APPROVED
Limited building only review
Permit holder responsible for full compliance with the code

PRELUDE H&H HOMES - GARAGE LEFT

TITLE	REVISION LOG

PRELUDE - GARAGE LEFT
H & H HOMES

MAIN FLOOR PLAN
 SCALE: 1/4" = 1'-0"
GARAGE LEFT

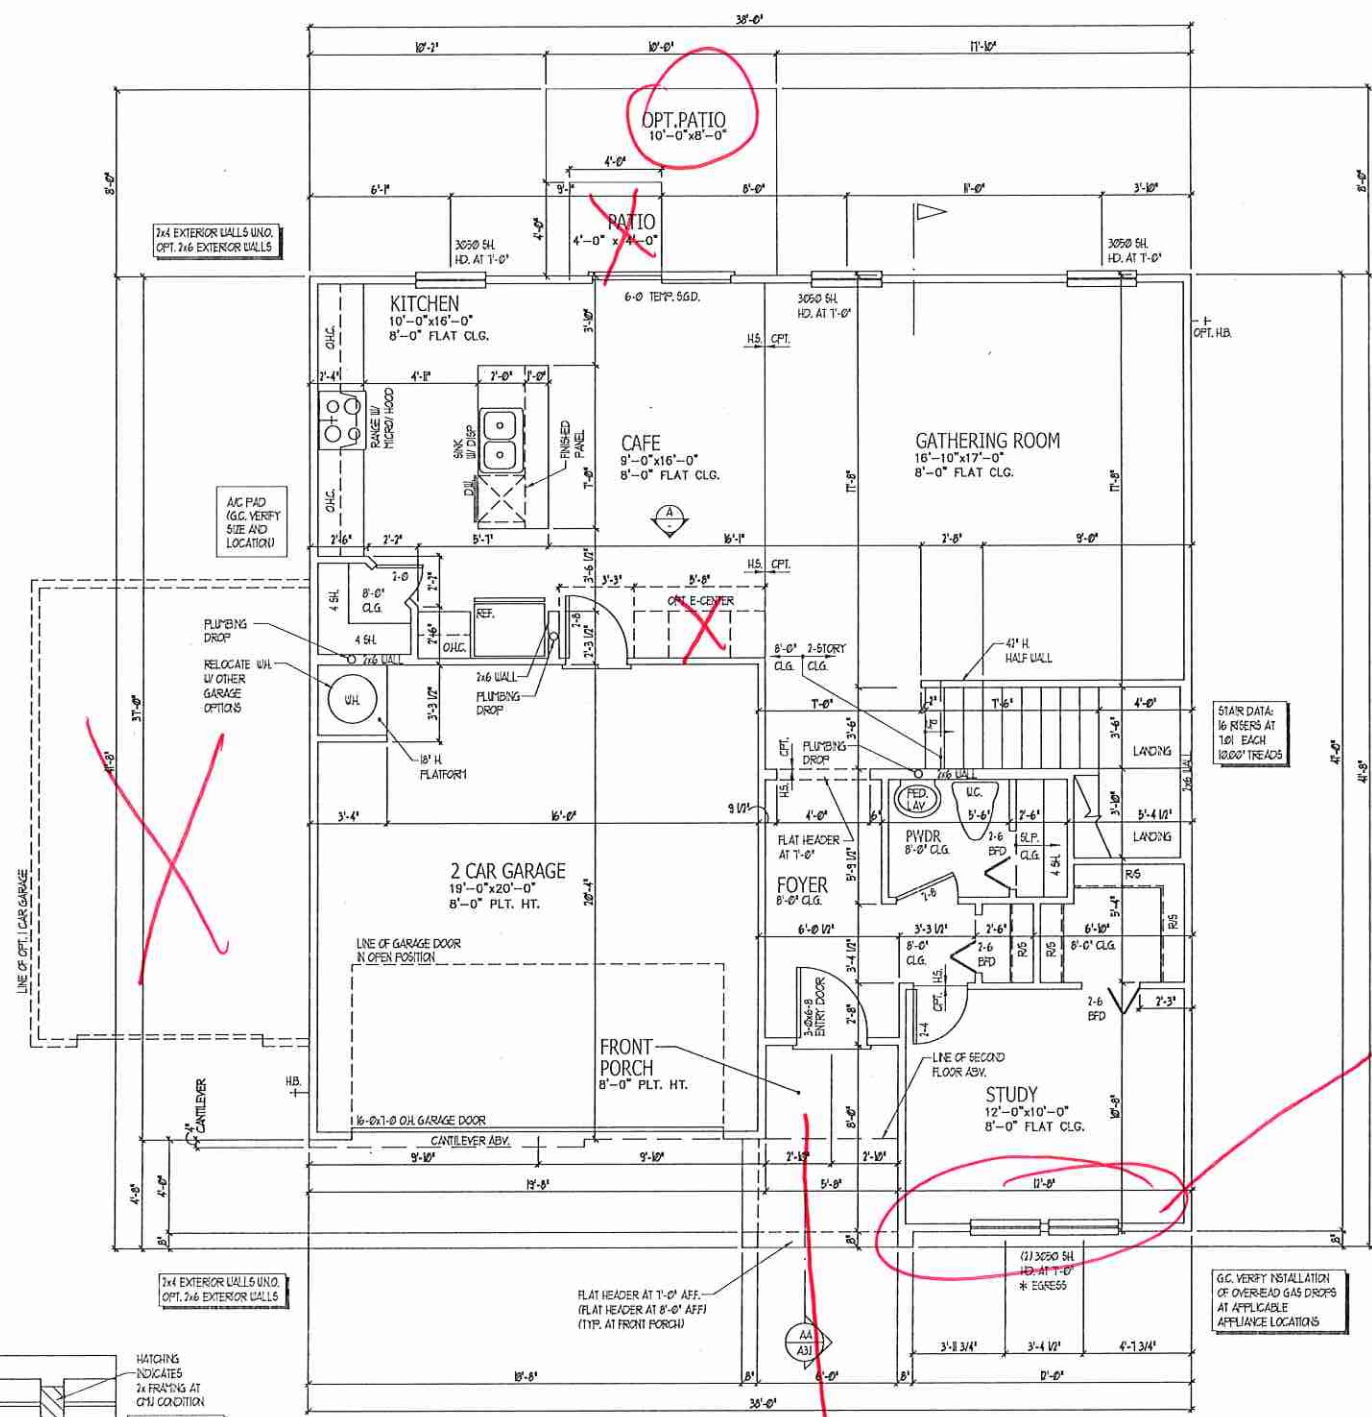
Per Elevation C

Elev. C Fr. porch

UPPER FLOOR PLAN
 SCALE: 1/4" = 1'-0"
 GARAGE LEFT

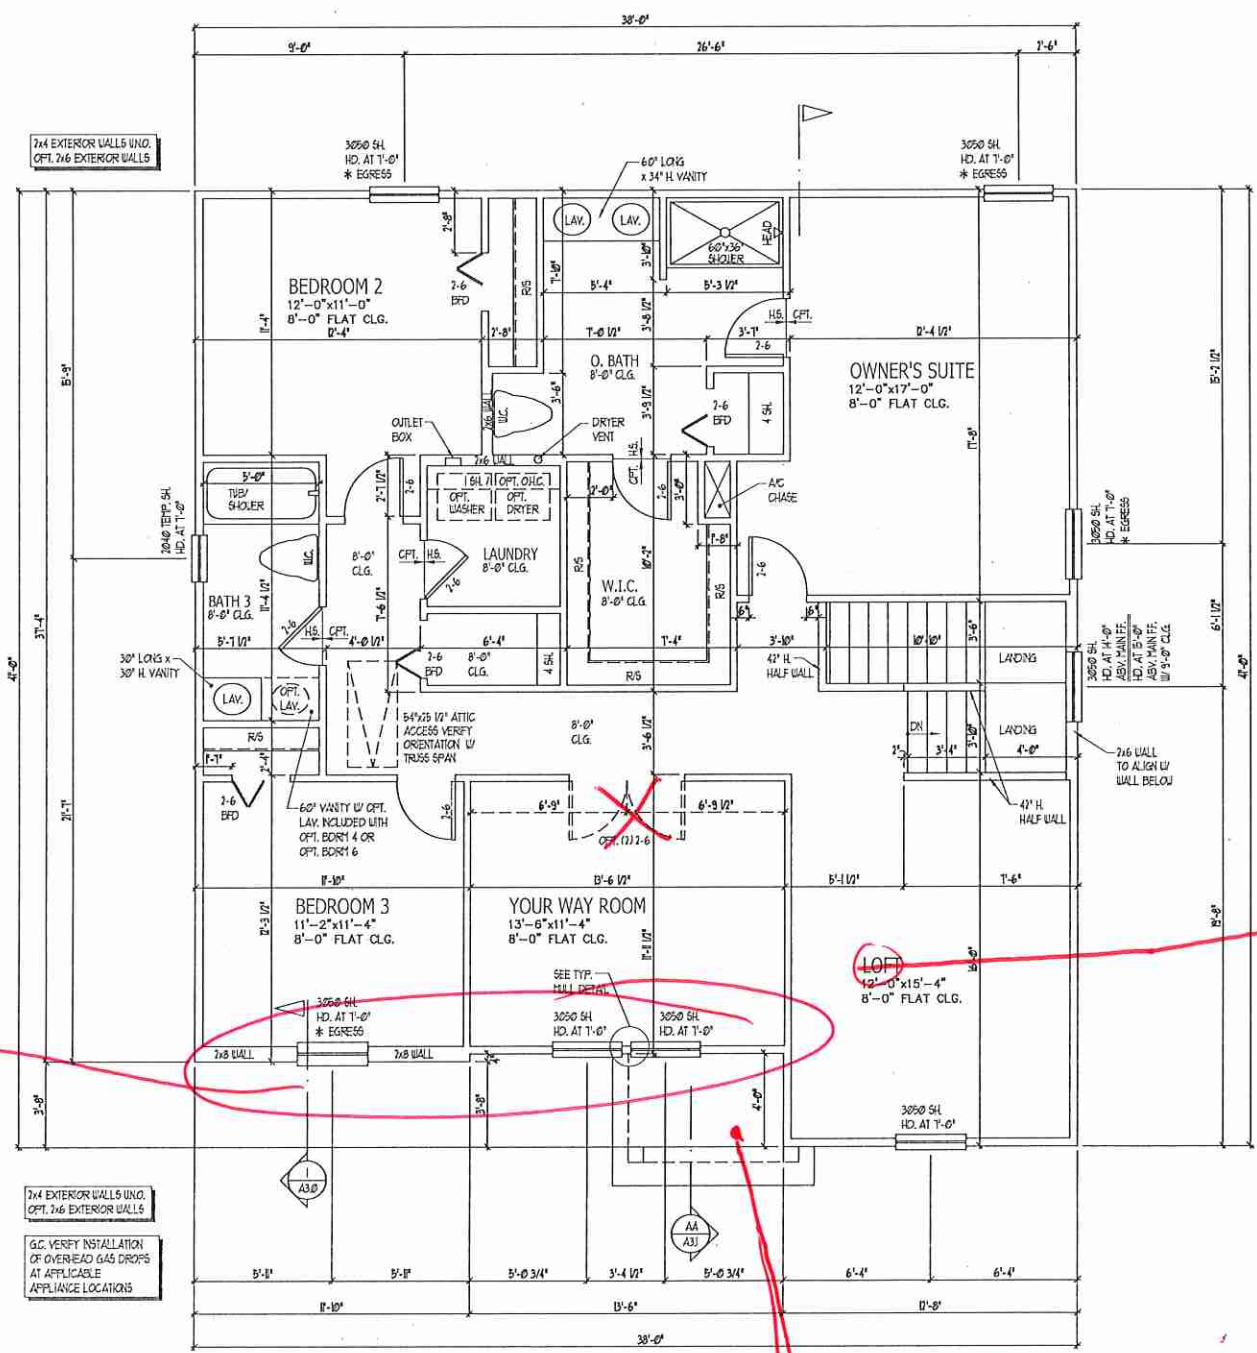
Windows per Elev. C

Bed 6 Option

See Elev. C front porch

**MAIN FLOOR ELECTRICAL PLAN
 GARAGE LEFT**

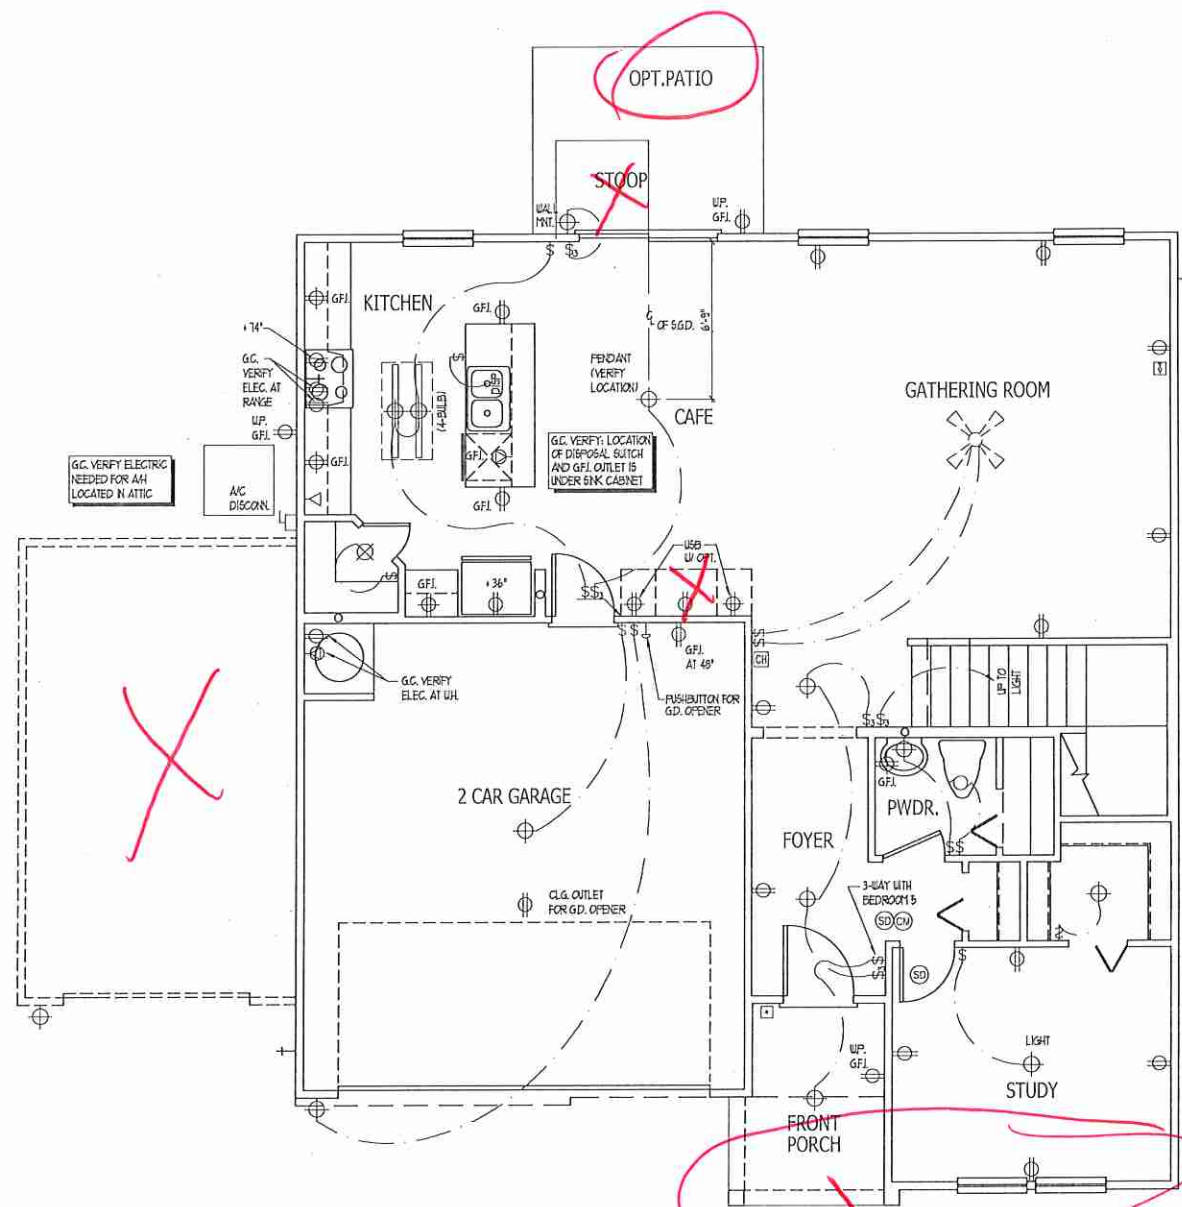
Sec Elev. C

UPPER FLOOR ELECTRICAL PLAN
 GARAGE LEFT

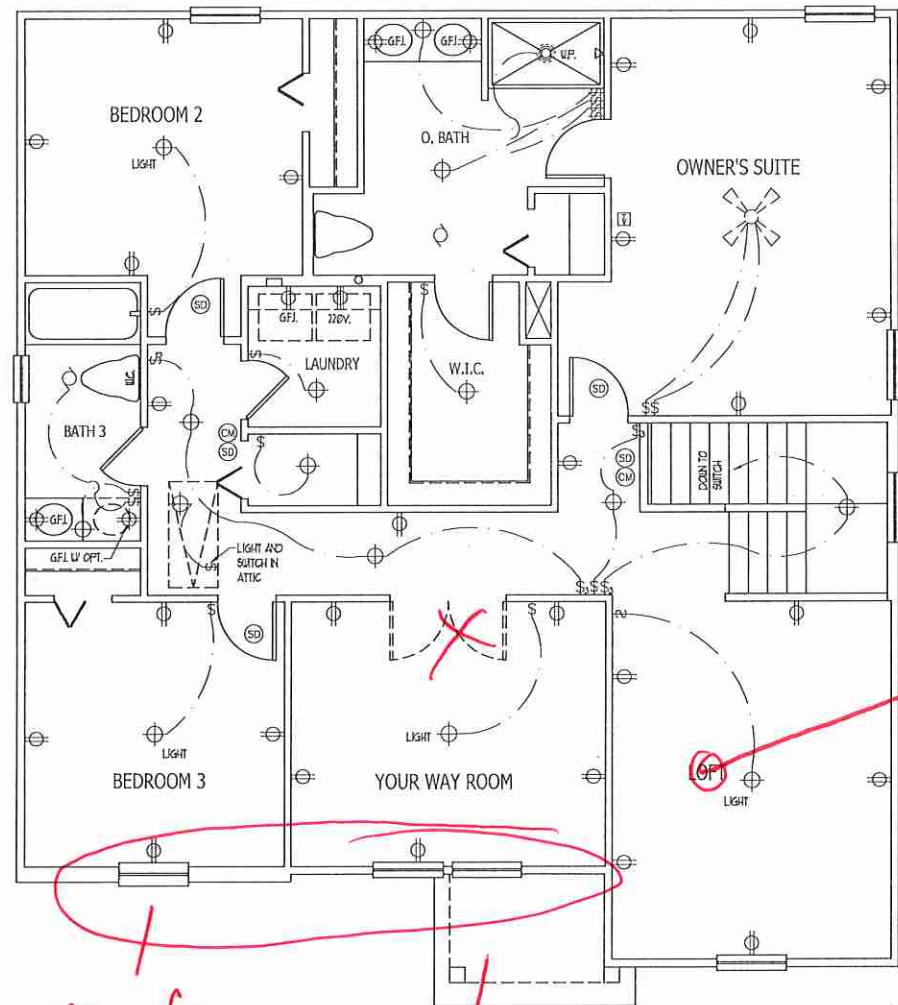
See Elev. C

Elev. C front porch

Bed 6
